SUBJECT: DYMIDAG THREADBAR SYSTEM FOR SPLICING OF REINFORCING
STEEL BARS - NINE MILE POINT 2

Plant Name: Nine Mile Point 2
 Docket No.: 50-410
 Licensing Stage: Post CP
 Responsible Branch and
 Project Manager: Licensing Branch 1, Kenneth L. Kiper
 Description of task: Review of DYMIDAG Threadbar System for Splicing
of Reinforcing Steel Bars
 Review Status: Completed

Niagara Mohawk Power Corporation
Nine Mile Point Unit 2
Docket No. 50-410

DYWIDAG Threadbar

DATE	SCALE	DWG
APPROVED		NRC-1

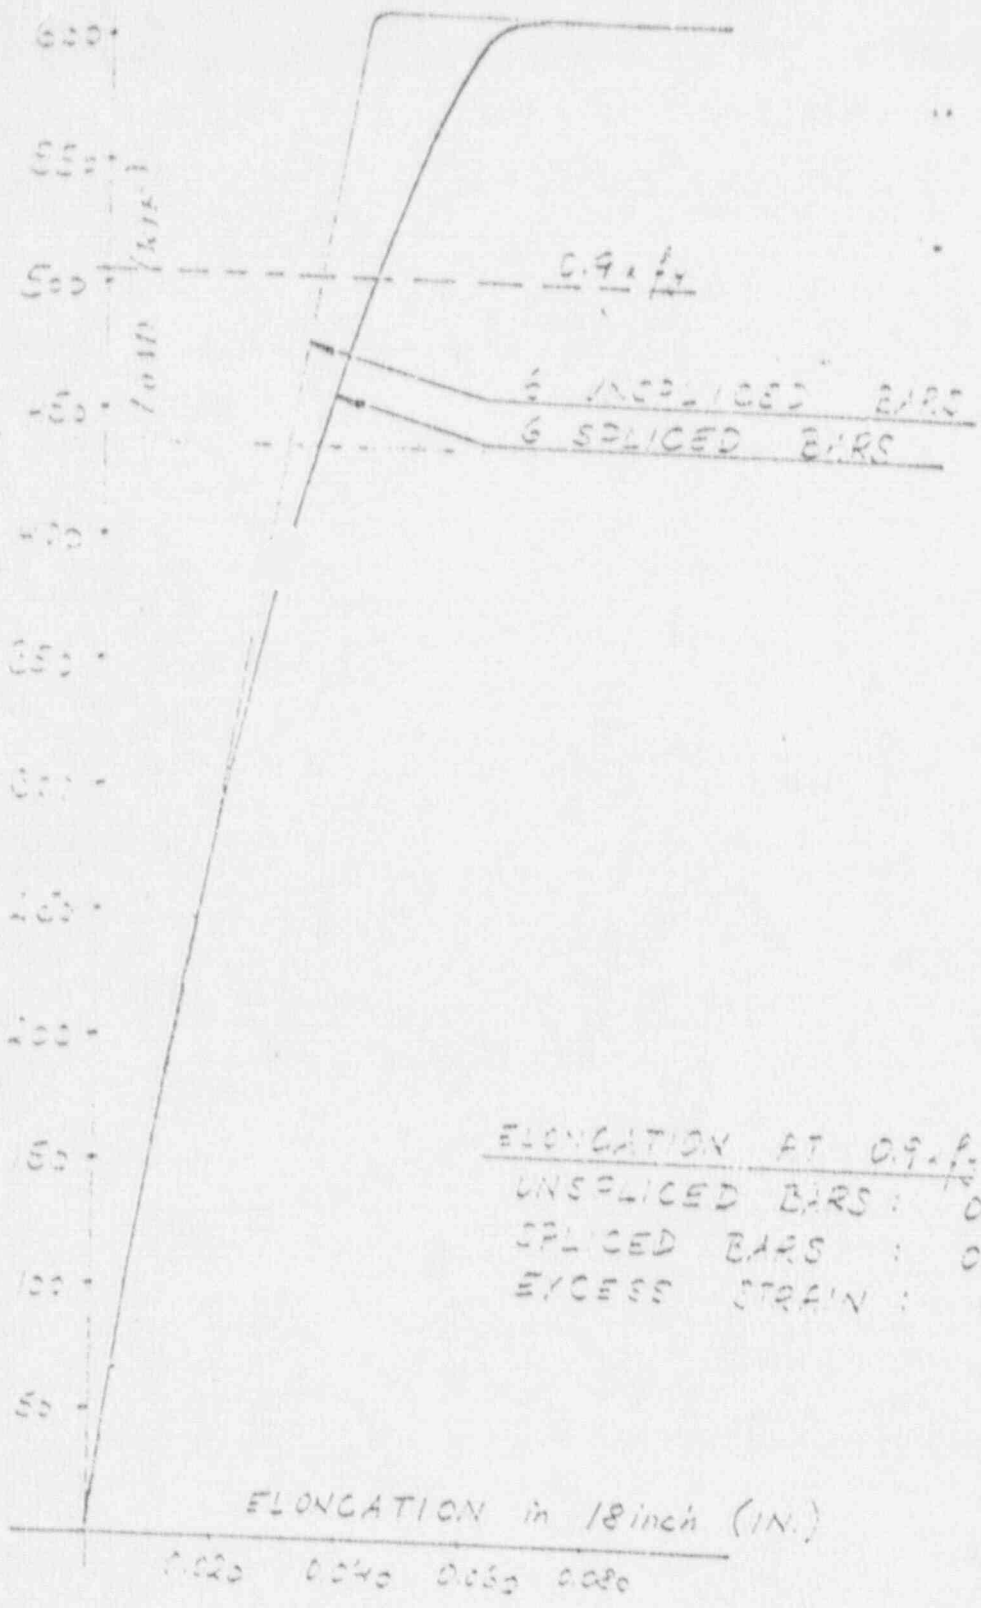
- c. Tensile test data on spliced (unstaggered) specimens consisting of group of bars to determine their efficiency. Preferably, the number of bars in a group should be at least five. These data should be provided for bar sizes 11, 14, and 18. Compare the these results with similar unspliced specimens. The test shall be performed and reported in accordance with Section CC-4333.2 of the above mentioned ASME code.

DWIDAG Threshor Splice System (grade 60 ksi)
 Combination of 6 - #11 Splices

Columbia University Test No. 82636, May 7, 1980
